SUBJECT: Plan For Remedial Action for Triangle Quarry  
Rock Slide of January 7, 1992

NOTICE OF MINE PERMIT DEFICIENCIES

RE: Triangle (Cary) Quarry (92-10)  
Wake County

SUBJECT: Wake Stone Corporation Triangle Quarry  
Summary of January 7, 1992 Blast and Factors Causing Rock  
Slide to Crabtree Creek.

SHOT DESIGN  
FOR JANUARY 7, 1992 SHOT

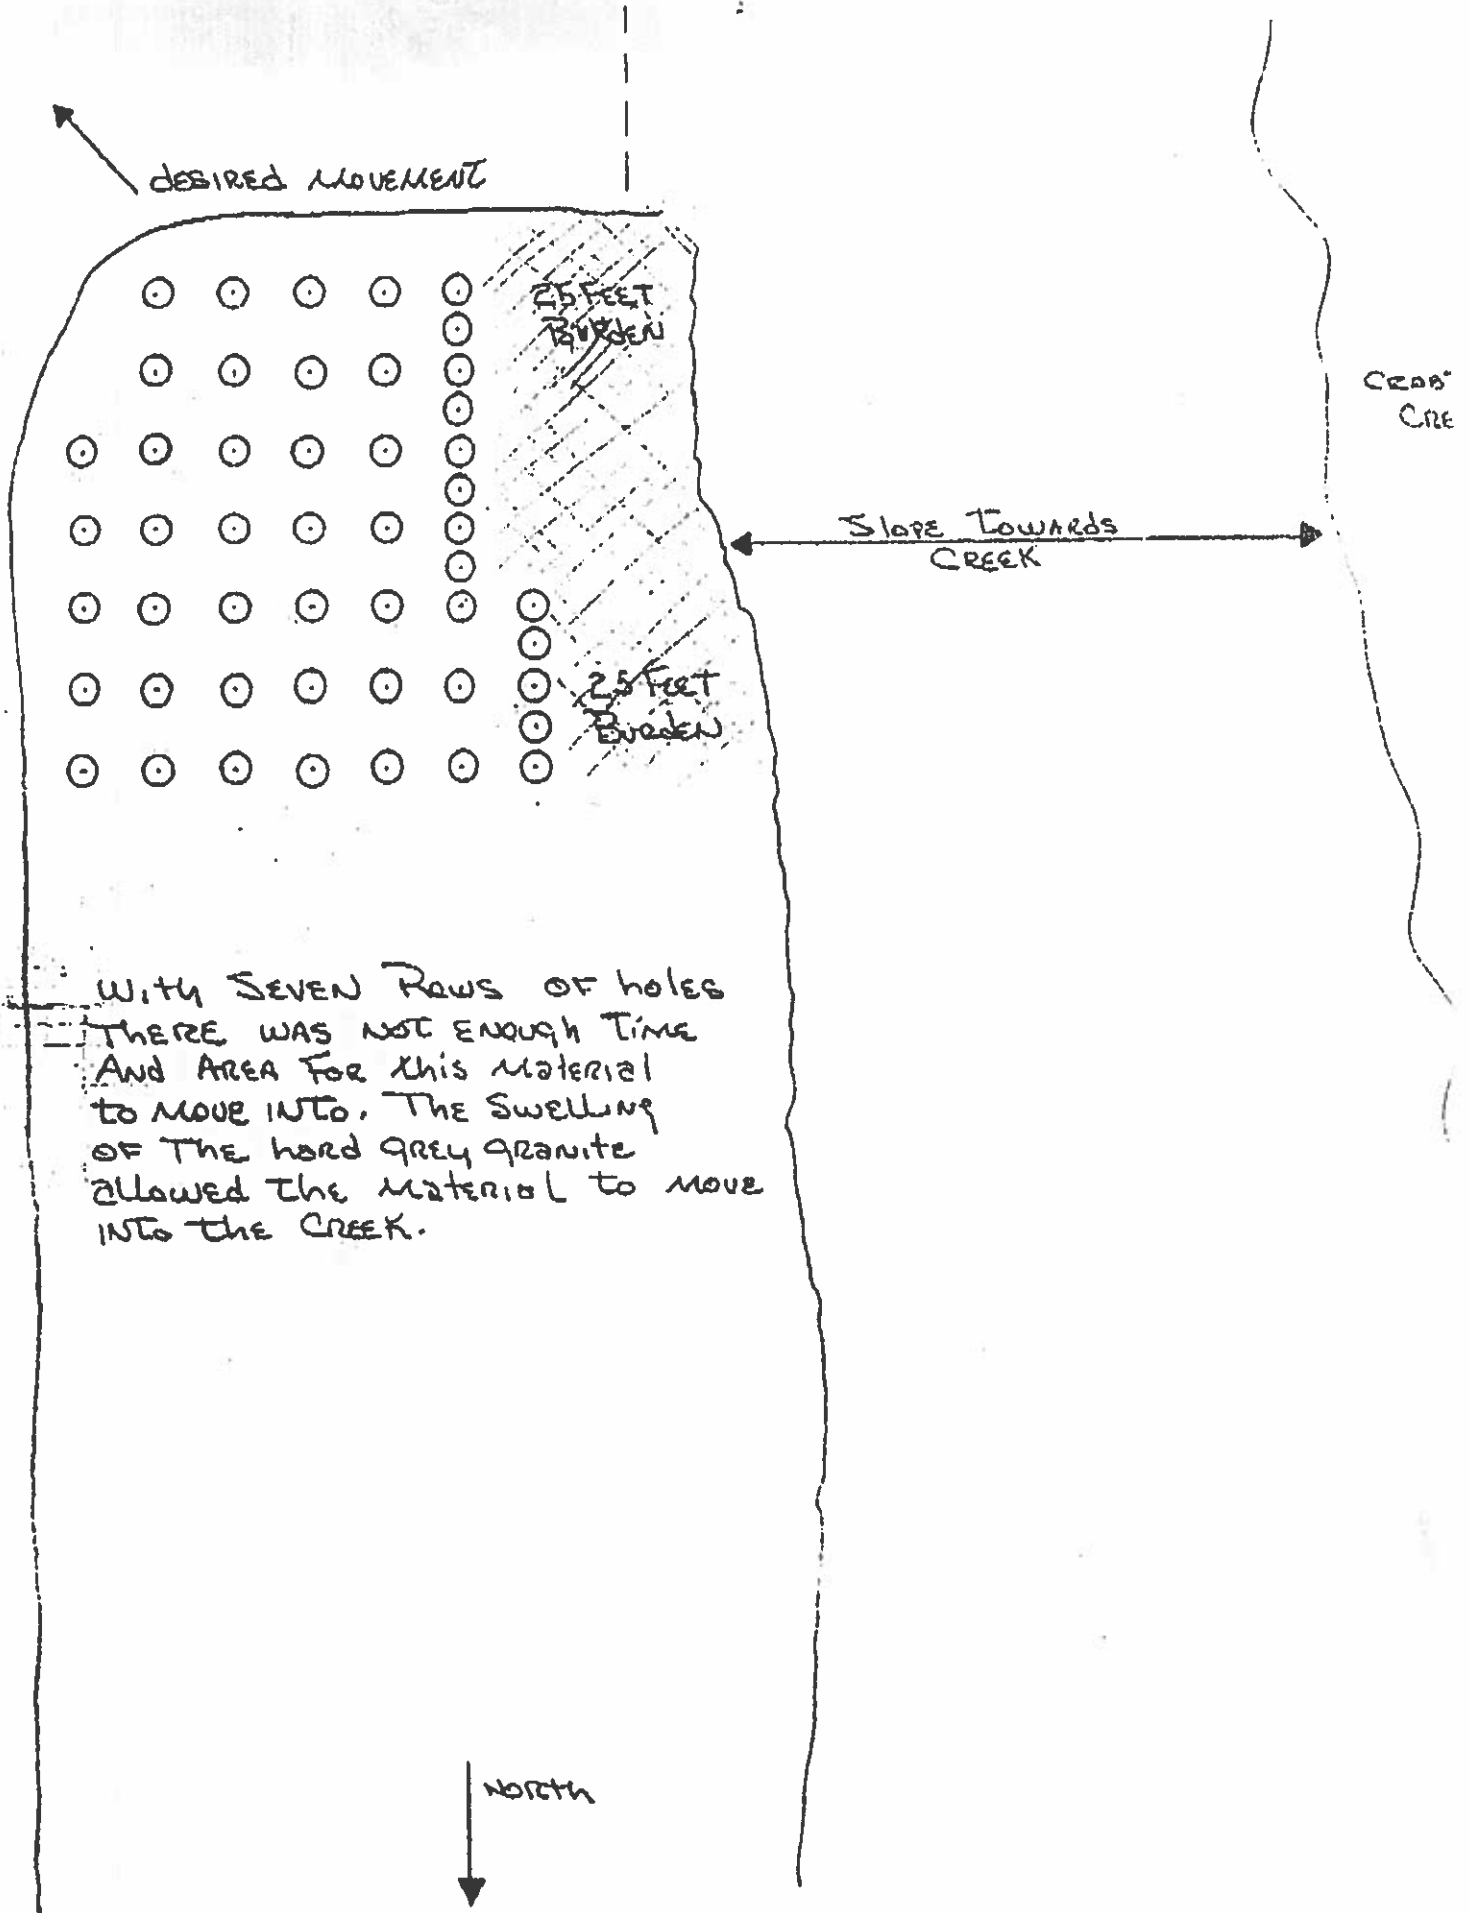
Shot data:  
 50 holes 4 inch diameter  
 8x8 PATTERN  
 Side OF Shot Toward CREEK  
 had 25 FEET burden

WITH SEVEN ROWS OF HOLES  
 THERE WAS NOT ENOUGH TIME  
 AND AREA FOR THIS MATERIAL  
 TO MOVE INTO. THE SWELLING  
 OF THE HARD GREY GRANITE  
 ALLOWED THE MATERIAL TO MOVE  
 INTO THE CREEK.

PROPOSED BLAST DESIGN LAYOUT  
FOR FUTURE SHOTS

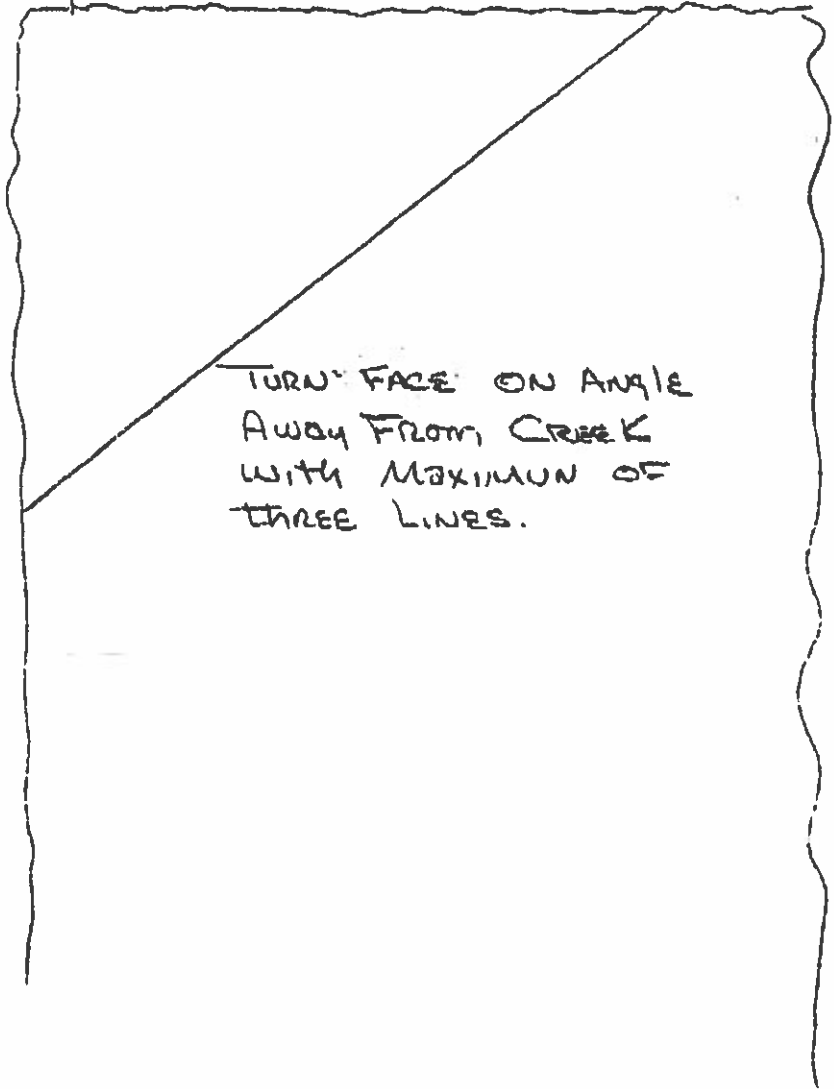
TURN FACE ON ANGLE  
AWAY FROM CREEK  
WITH MAXIMUM OF  
THREE LINES.
